Public Meeting Summary

Oklahoma Department of Transportation

**I-40 & Gary Blvd. (Exit 65) Interchange
Custer County, JP 31482(04)**

May 22, 2019

Figure 1: Alternative 7 Overview

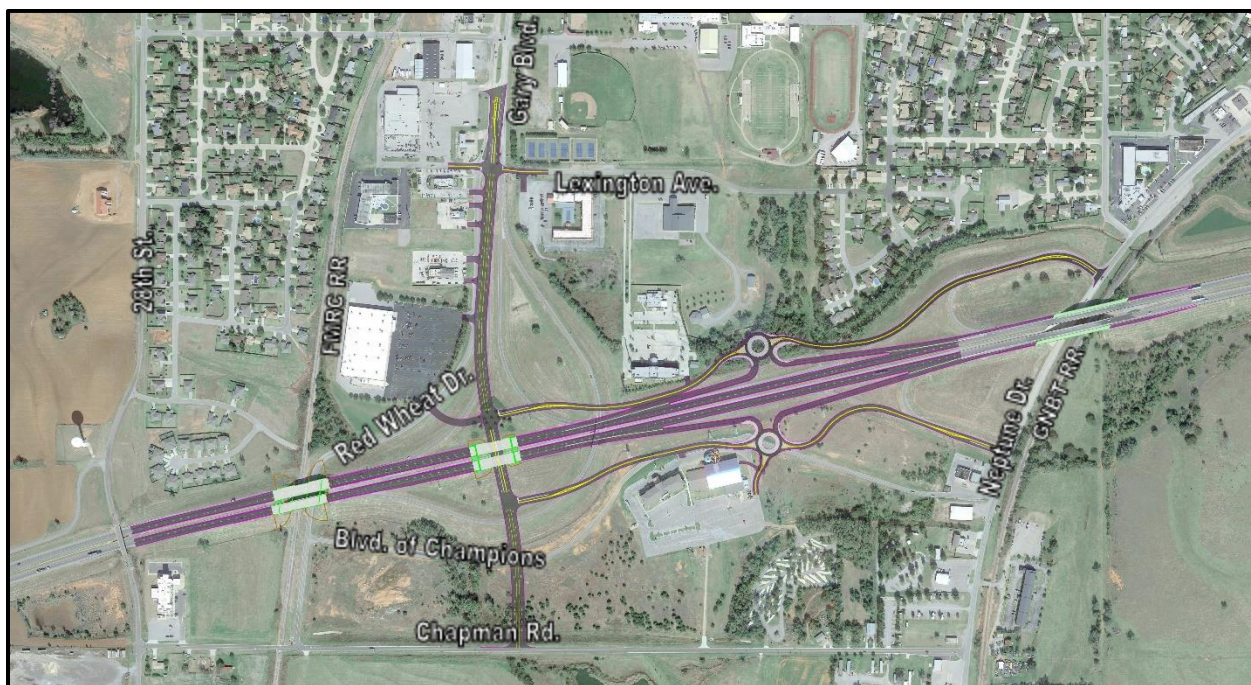
- Will the roadway be asphalt or concrete? *Still looking into it.*
- The roundabouts will need signage to direct people.
- What will be the speed limits on the ramps and in the roundabout? *Speed limit in the roundabouts will be 15 mph. The ramps are designed to be longer than normal to allow more time for acceleration and deceleration.*

- What are the dimensions of the roundabouts? *They have a radius of 55-60 feet (120 feet inside diameter, 150 feet outside diameter). They were designed to accommodate a double semi-trailer.*

- What is the distance between Gary Blvd. or Neptune Dr. and the roundabout? *Approximately 2000 feet (less than ½ mile).*
- Thank you for keeping Exits 65 and 65A. Will this affect the use of businesses on Gary Blvd. or travel times to residences near Neptune because of increased distances/out of direction travel? *This solution is the result of much study by several groups to try and keep both interchanges*

- Is this the only option? What about the diverging diamond? *This is the best option to keep both interchanges open.*
- How will this help traffic at the Gary/Lexington/Oliver intersection? *It will become a more traditional four-leg intersection and less confusing for drivers. It eliminates multiple roadways in same direction (e.g. WB ramps, Red Wheat Drive).*

- What will be the elevation change on I-40? *Estimate about 7-8 foot raise on I-40 to accommodate new bridges. There will be excavation under I-40 for the new Gary Blvd.*
